**J-3 Comments on the Draft EA
and FAA Responses**

Comments and Responses Volume 2

RE: Comments on the FAA’s South-Central Florida Metroplex Draft Environmental Assessment

FLL Comments - FAA South-Central Florida Metroplex Draft EA - July 23, 2020

FLL AARPS RNAV SID – Departure percent not defined

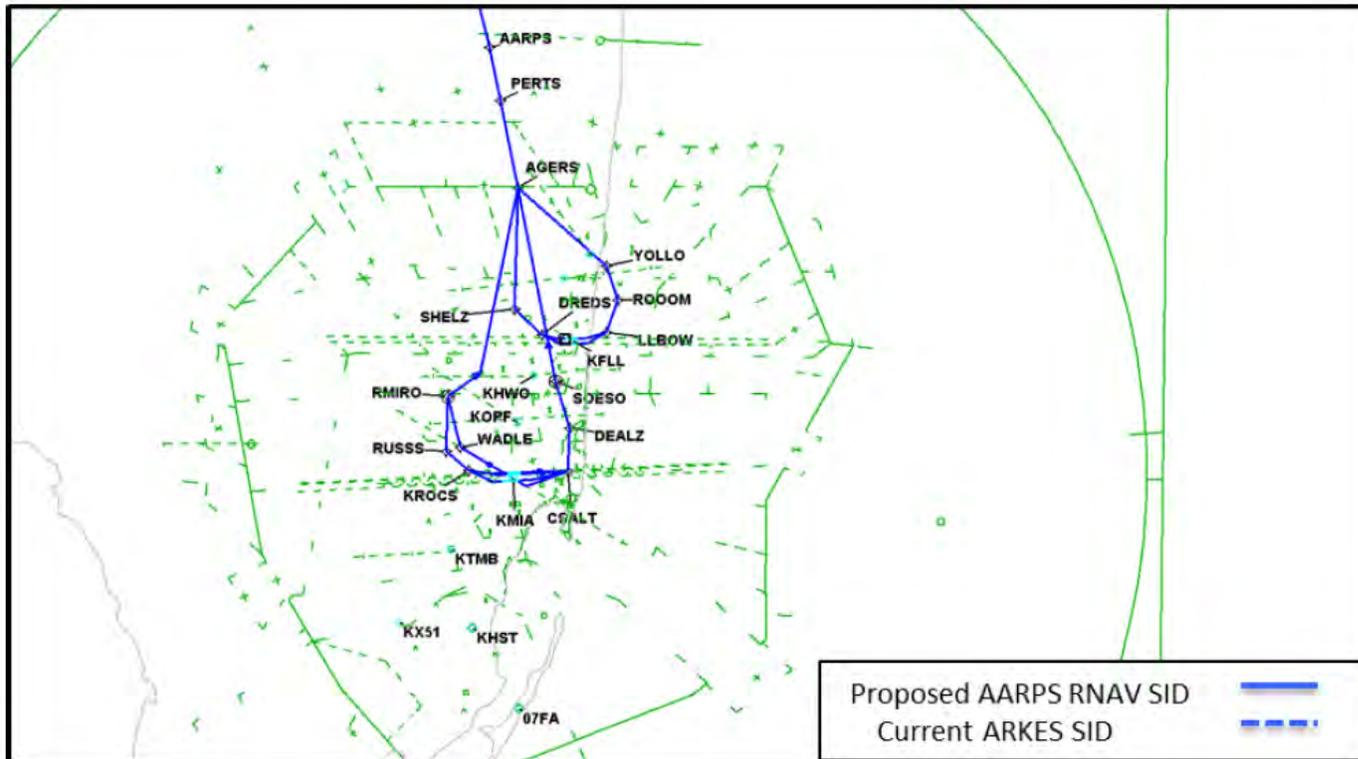
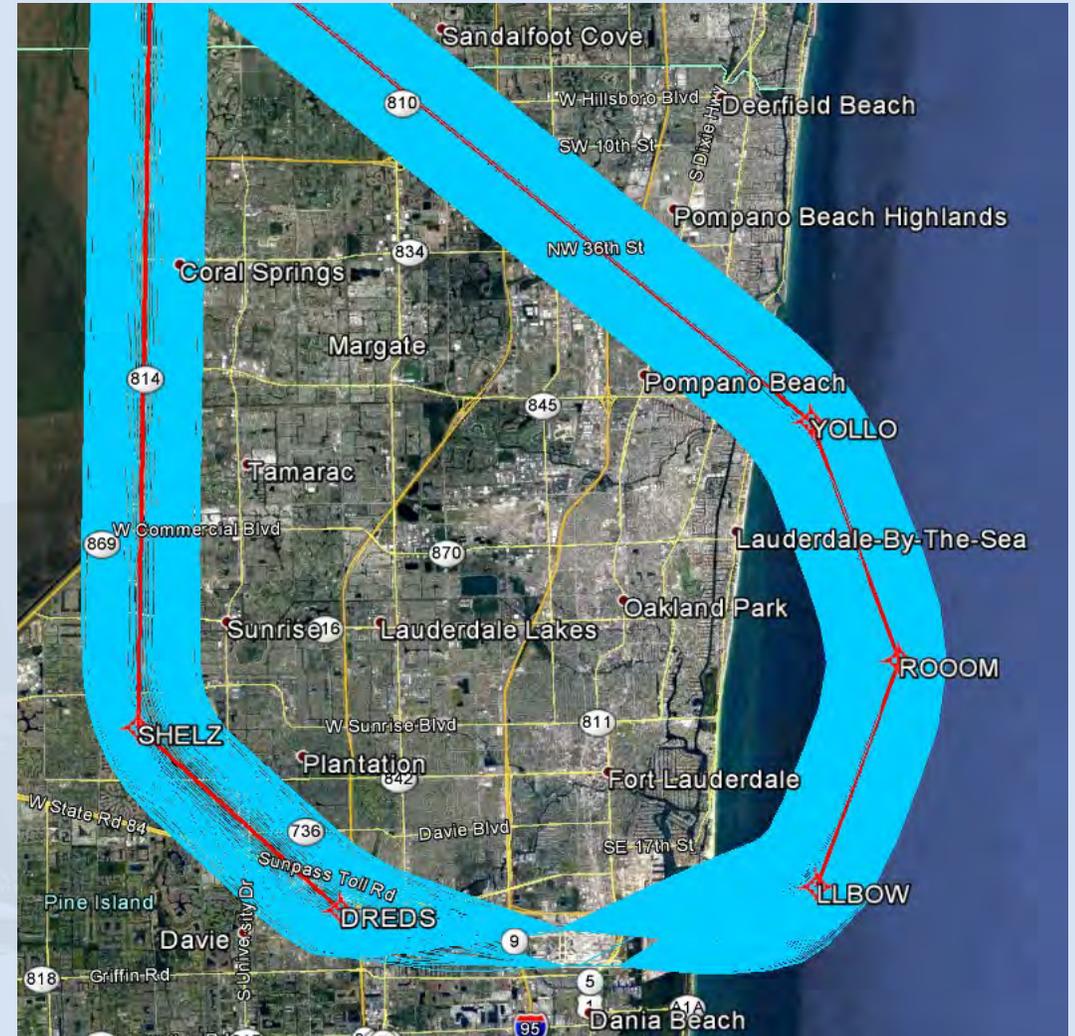
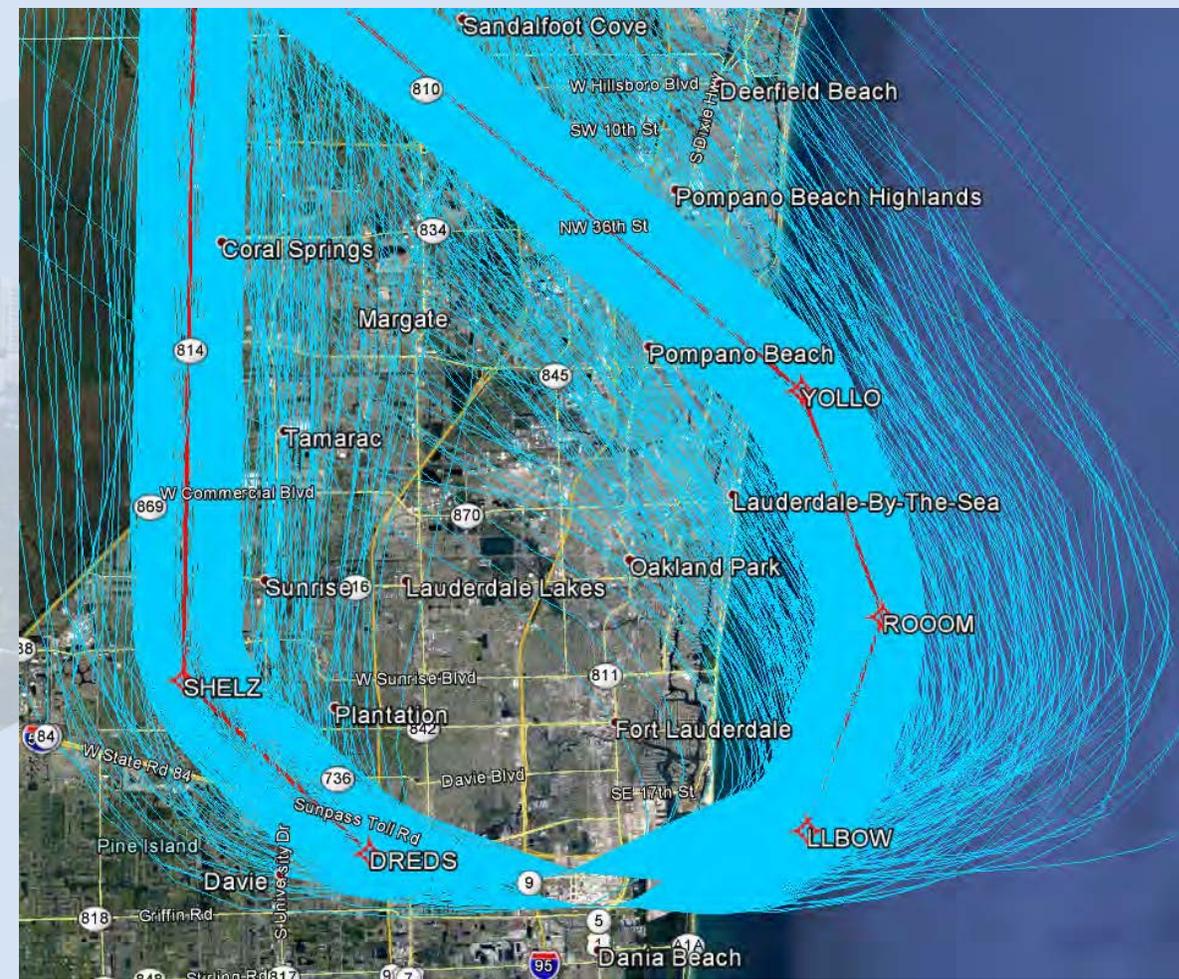
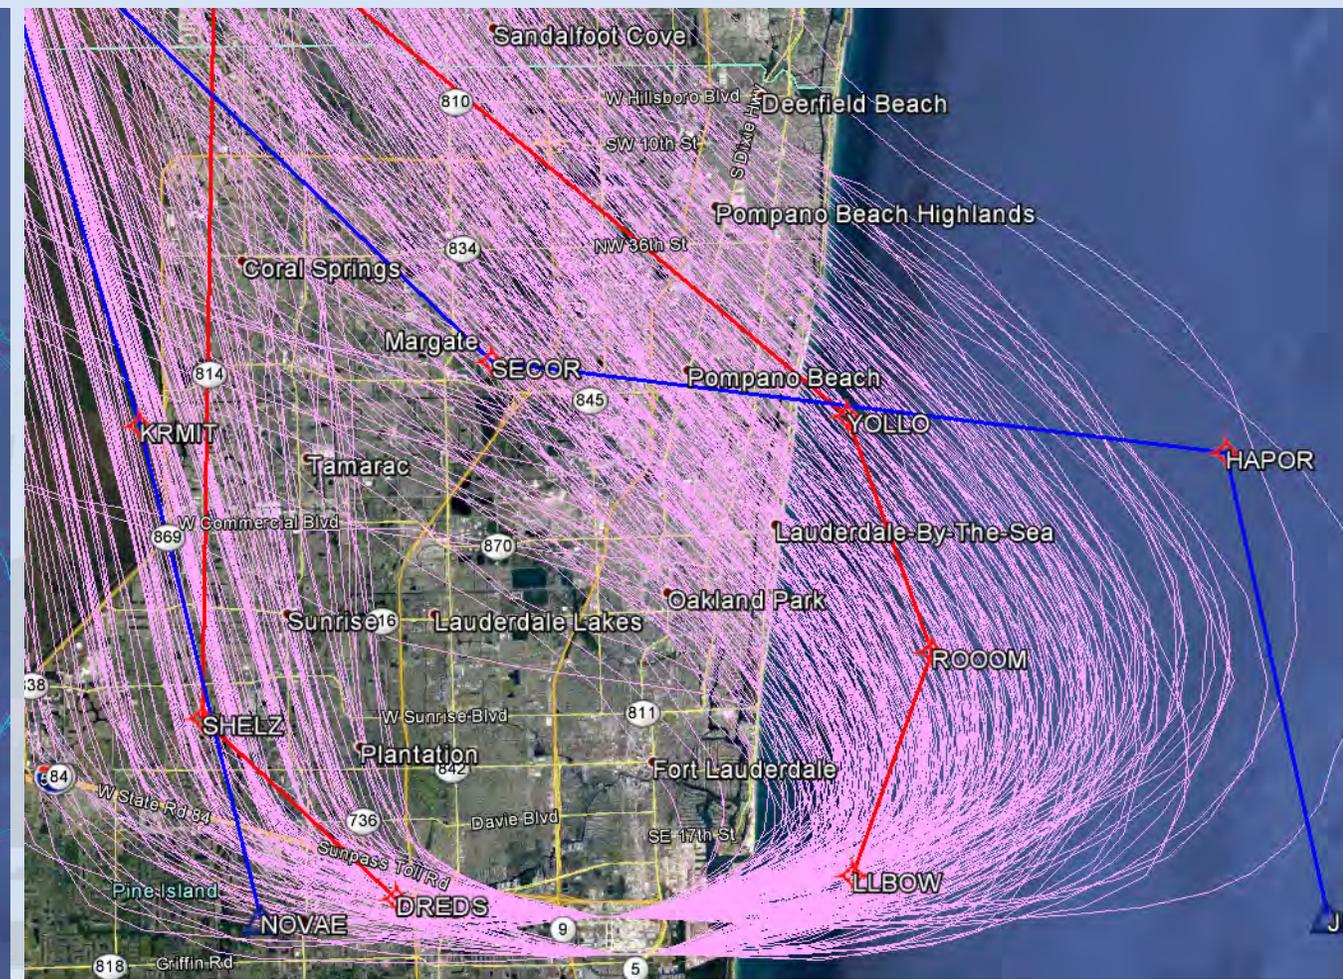
Broward County Aviation Dept. (BCAD)	Winston Cannicle, Noise Information Officer, wcannicle@broward.org; 954-359-6181	FLL	AARPS SID	Pembroke Pines, West Hollywood, Davie, Plantation, Sunrise, Tamarac, Weston	This procedure has the potential to create community concerns where concentrated tracks cross back over the coast in Pompano Beach. Additionally, this procedure will concentrate overflights especially in areas to west between DREDS, SHELZ and AGERS.	Slides 5-6 Attachment A
Broward County Aviation Dept. (BCAD)	Winston Cannicle, Noise Information Officer, wcannicle@broward.org; 954-359-6181	FLL	BAHIA STAR	West Plantation, Weston, West & East Fort Lauderdale, Oakland Park, Wilton Manors	It appears that the BAHIA STAR is generally consistent with the existing CORSO STAR, but will generally concentrate tracks north of the City of Fort Lauderdale during west flow. This could result in community concerns.	Slides 24-25 Attachment A

FLL SNAPR RNAV SID – 11% of Jet Departures

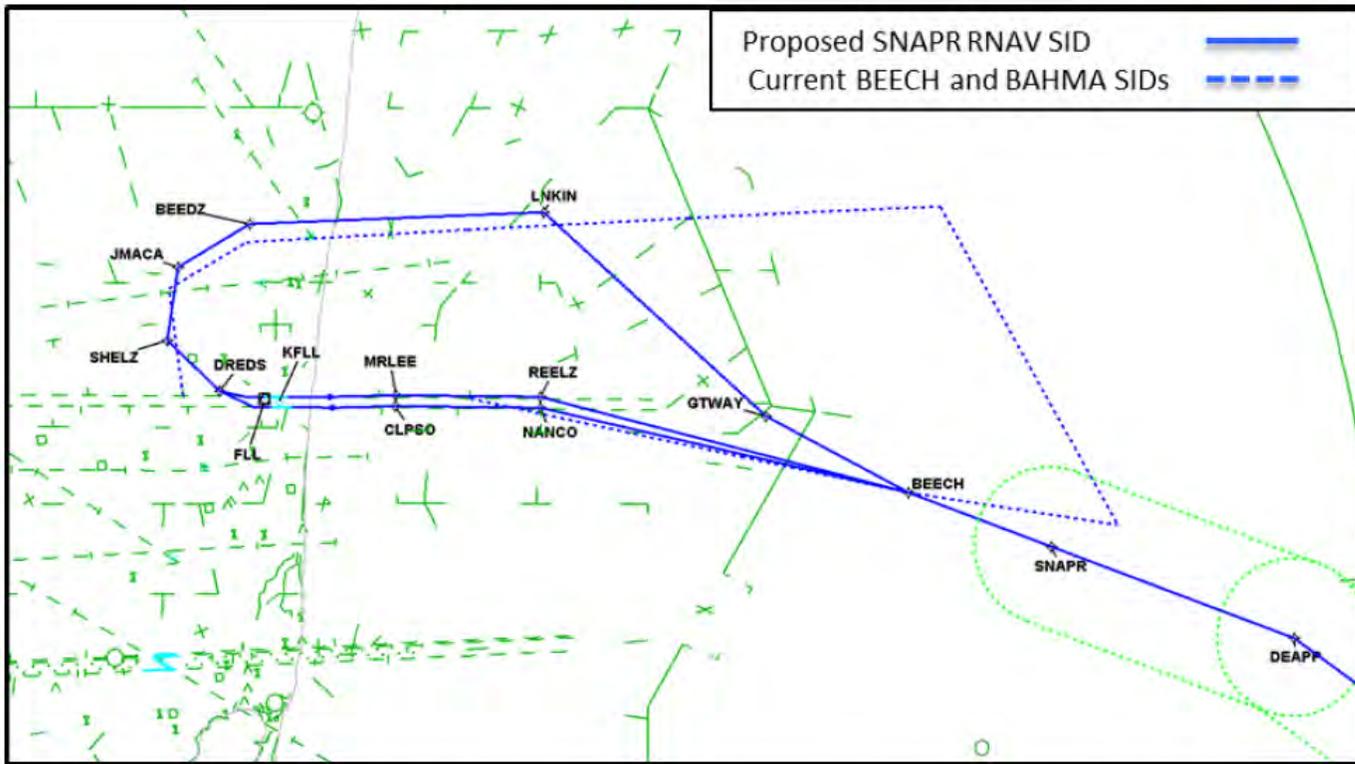
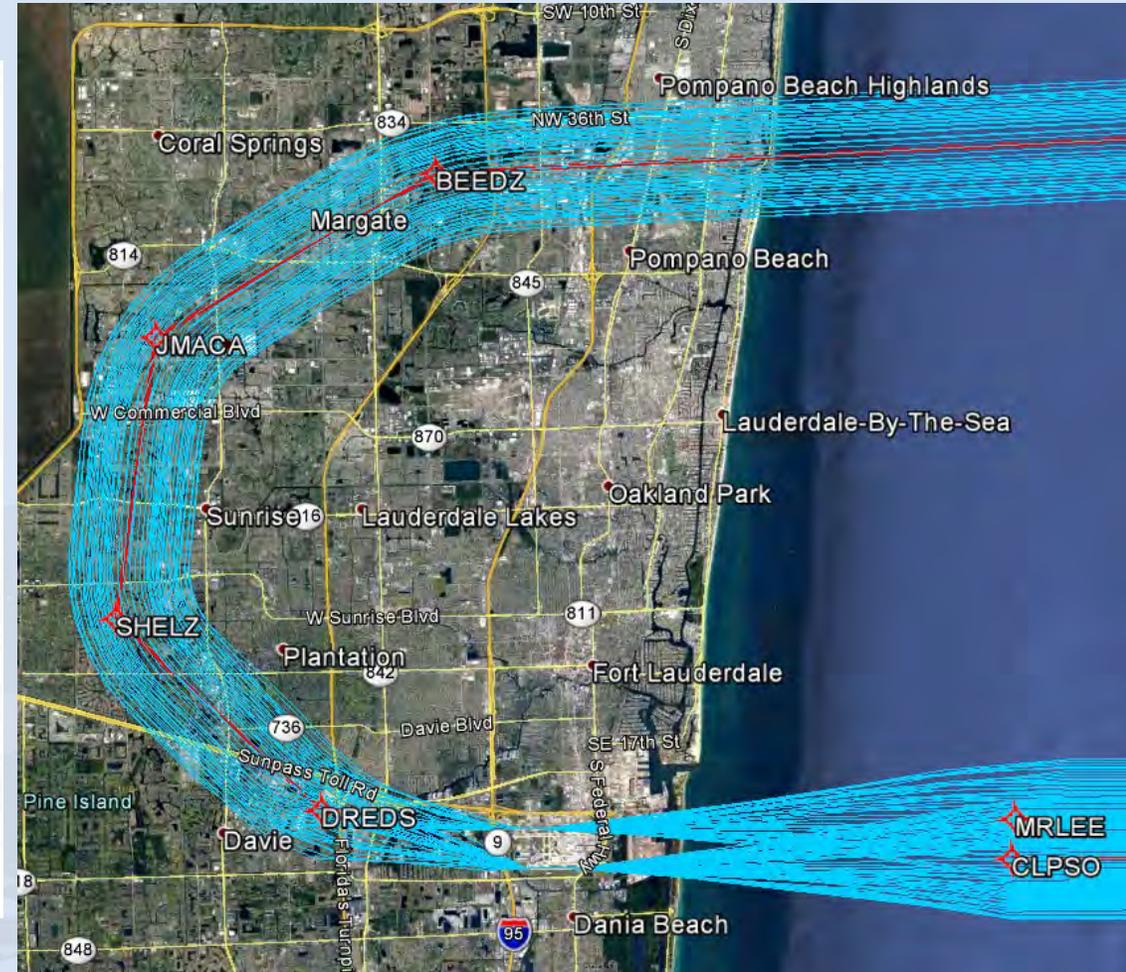
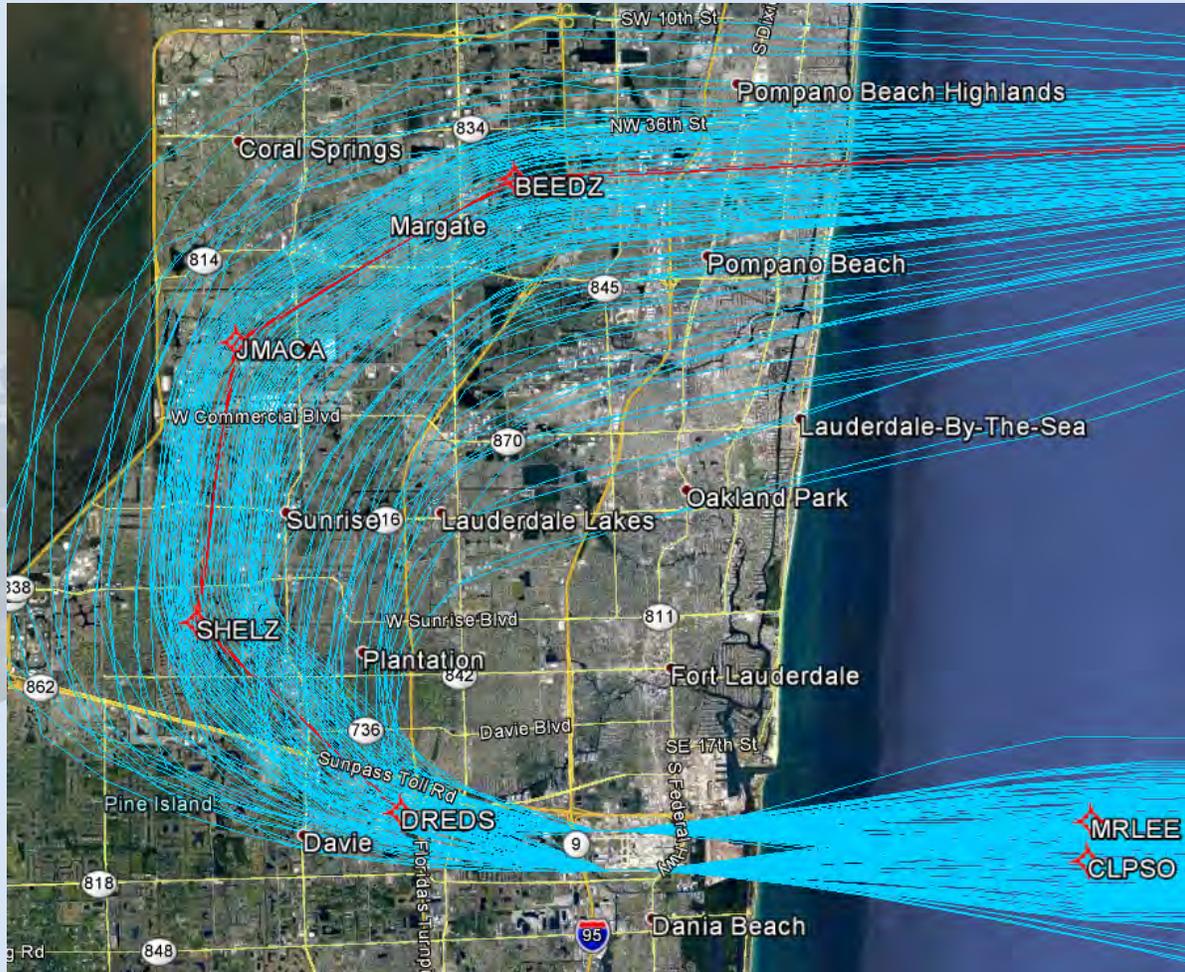
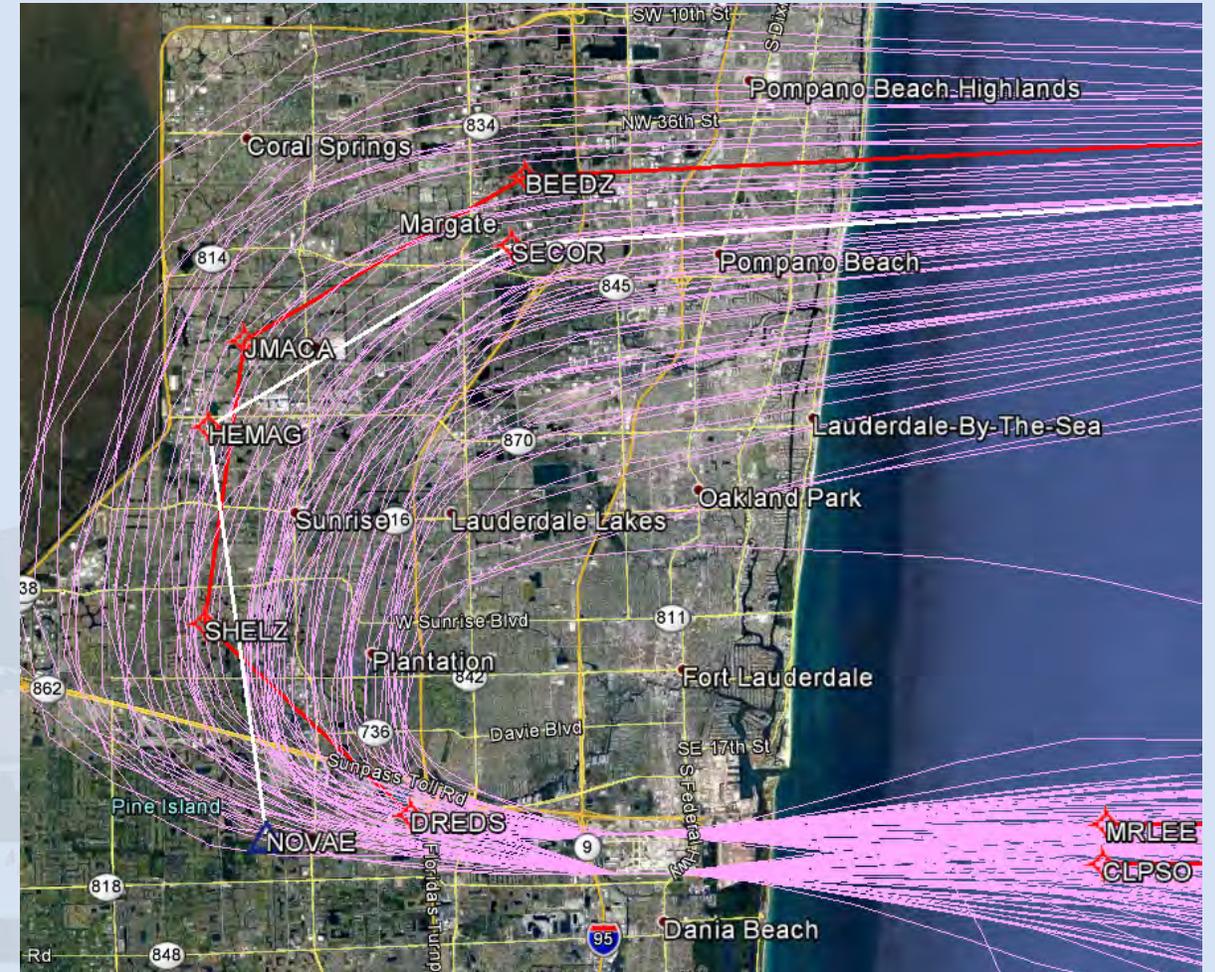
Broward County Aviation Dept. (BCAD)	Winston Cannicle, Noise Information Officer, wcannicle@broward.org; 954-359-6181	FLL	SNAPR SID	Departure	Davie, West Plantation, Sunrise, North Tamarac, Pompano Beach	This procedure will concentrate departing flight paths west/northwest over different paths than PREDA4 . This will result in community concerns, especially in areas at SHELZ and JMACA	Reduce separation between waypoints for DREDS and SEAZZ		DREDS waypoint was moved .25 mile SE. This procedure will concentrate departing flight paths west/northwest over different paths than BEECH and BAHMA SIDS . This may result in community concerns during west flow, especially in areas at SHELZ and JMACA and BEEDZ and may concentrate flights transitioning over coast. FAA indicated an 11 departure heading separation to the east and west in June 2020 public workshops.
Broward County Aviation Dept. (BCAD)	Winston Cannicle, Noise Information Officer, wcannicle@broward.org; 954-359-6181	FLL	TWTZTR SID	Departure	Pompano Beach, Dania Beach, Davie, Weston	This procedure has the potential to create community concerns where concentrated tracks cross back over coast in Pompano Beach. Straight-out paths to west are more consistent with historic paths but concentrate departing aircraft over areas that are currently receiving limited departure overflights	Departures to the east should remain on runway centerline longer before making turns to LLBOW and LEGG waypoints		No change made. This procedure has the potential to create community concerns where concentrated tracks cross back over the coast in Pompano Beach. Straight-out paths to west are more consistent with existing THNDR SID but concentrate departing aircraft over areas that are currently receiving limited departure overflights
